Serial No. NA3-08-091R  
Docket No. 52-017  
COL/MEP

**DOMINION VIRGINIA POWER**  
**NORTH ANNA UNIT 3 COMBINED LICENSE APPLICATION**  
**RESPONSE TO REQUEST FOR ADDITIONAL INFORMATION LETTER NOS. 011,**  
**013 AND 021 (FSAR CHAPTERS 1, 5, 13, 14 AND 17)**

On July 28, 2008, the NRC requested additional information to support the review of certain portions of the North Anna Unit 3 Combined License Application (COLA). The responses to the following RAIs are provided as Enclosures 1 through 18:

**NAPS COL 13.1-1-A Figure 13.1-204 Operating Organization**

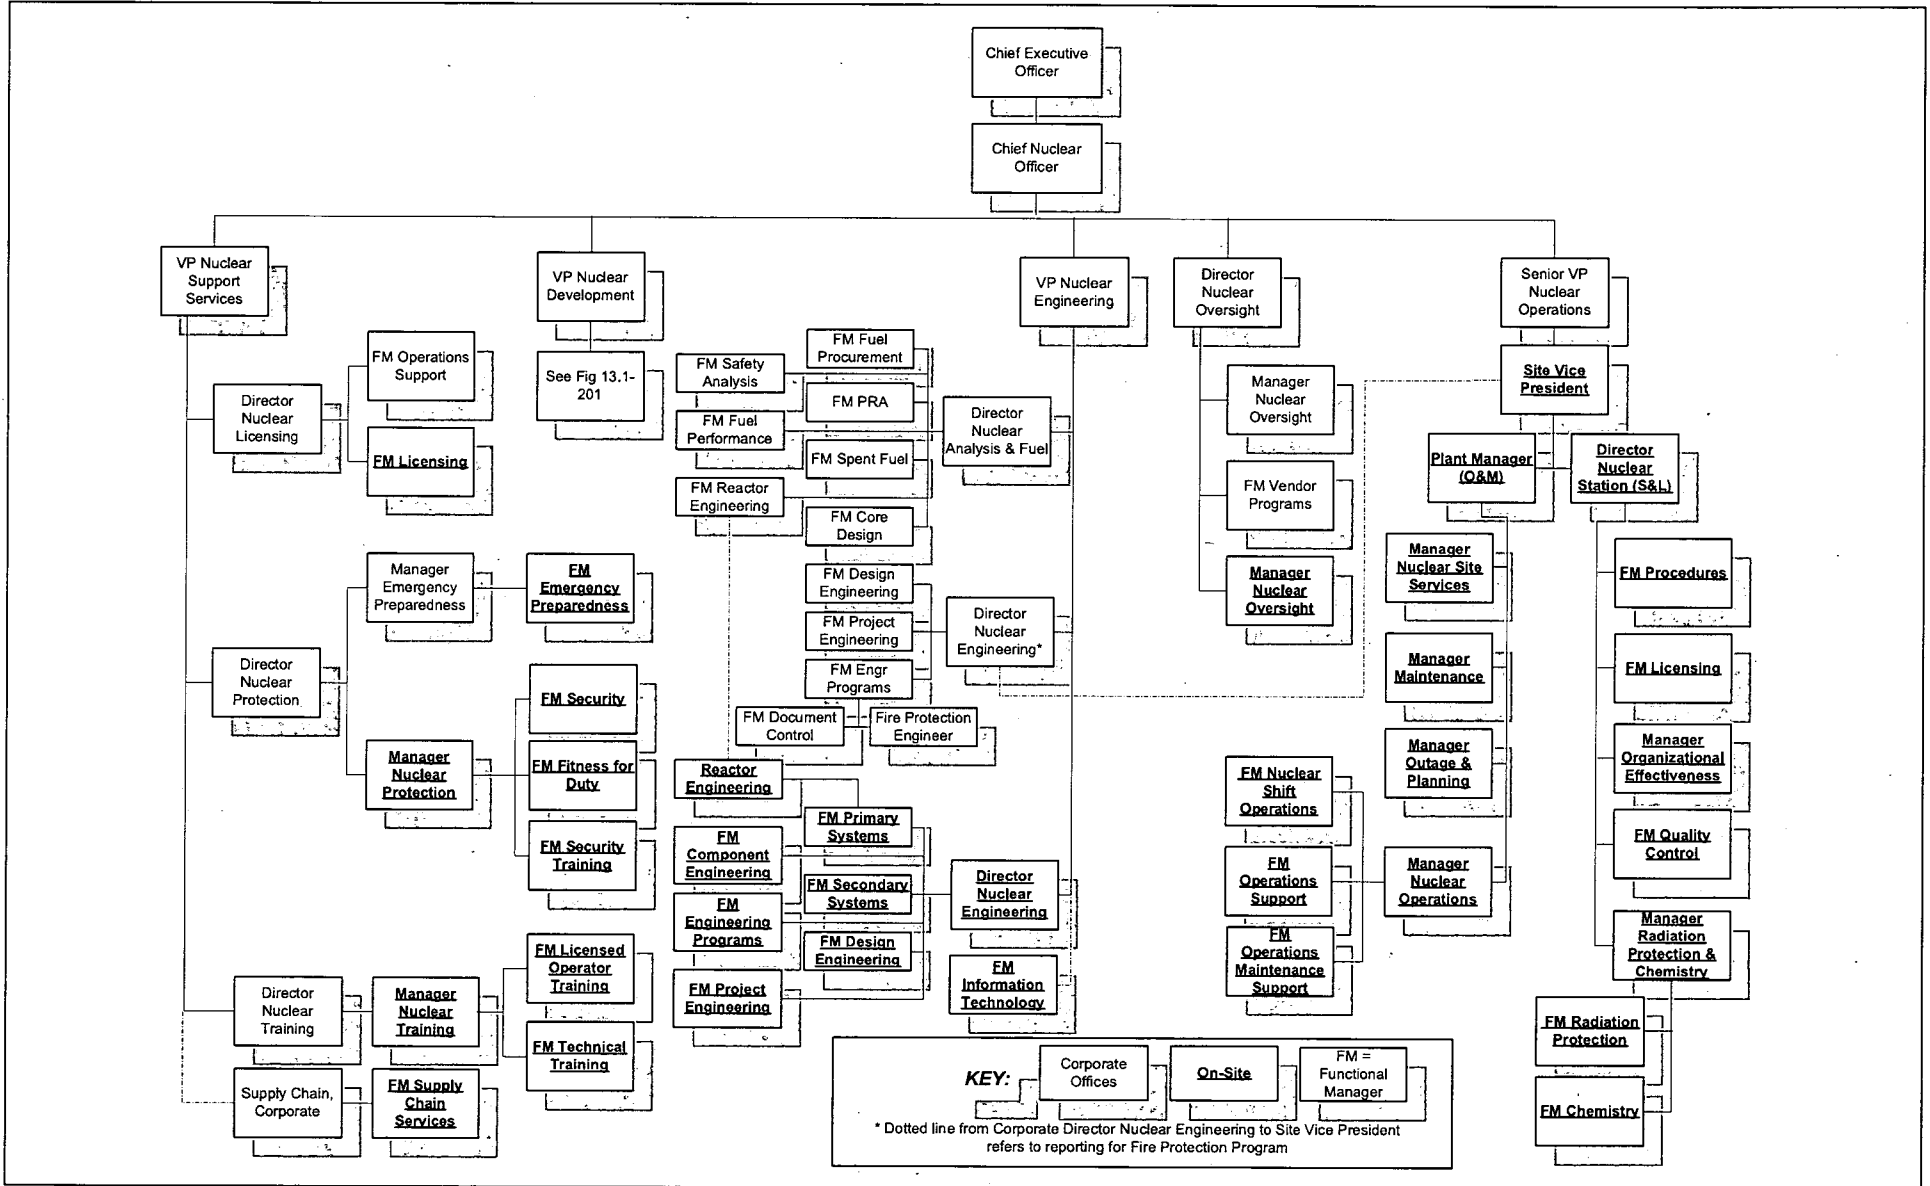
The plant management, technical support, and plant operating organizations are ~~incorporated into Section 17.5~~ shown in Figure 13.1-204. The operating organization is described in Sections 13.1.1.3 and 13.1.2. The on-shift organization is shown in Figure 13.1-203. Additional personnel are required to augment normal staff during outages.

The information requested by the RAI is found in Chapter 13. Section 13.1.2.1 describes the plant operating organization. This section will be corrected to indicate that the plant operating organization is shown in a new figure, Figure 13.1-204. The on-shift organization is shown in Figure 13.1-203. Section 13.1.1.3 is being revised in conjunction with RAI 13.01.01-2 (Enclosure 5), to provide a description of key executive and corporate management positions, functions, and responsibilities.
